Webster University Interdisciplinary Science Building
8274 Big Bend Blvd
Webster Groves, MO 63119

RE: 071326 Self Adhering Sheet Waterproofing (Base of Wall Foundation)

SUBMITTAL IDENTIFICATION SHEET

No. of Copies	Description	Submitted By
	071326 Self-Adhering Sheet Waterproofing	Superior Waterproofing
	• Base of Wall Waterproofing Foundation Detail

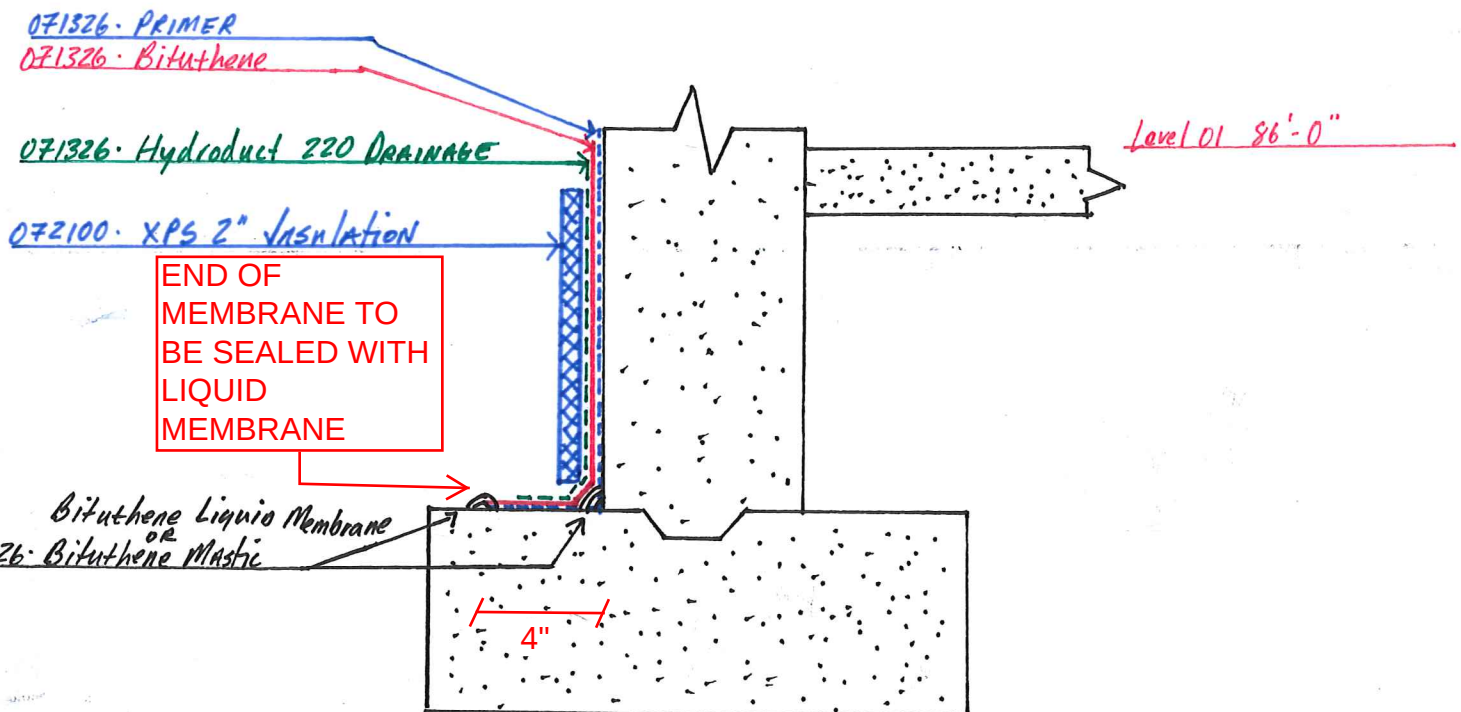
TERMINATE HYDRODUCT 220 AT EDGE BOND BEAM. TERMINATION SHALL BE PER MANUFACTURER'S PER GRACE'S DETAILS. ALL EXPOSED EDGES OF HYDRODUCT SHOULD HAVE FILTER FABRIC TUCKED BEHIND CORE TO SEAL LEADING EDGE TO PREVENT SOIL FROM ENTERING THE CORE. TERMINATION AT TOP (GRADE) SHALL BE PER CONSTRUCTION DOCUMENTS.
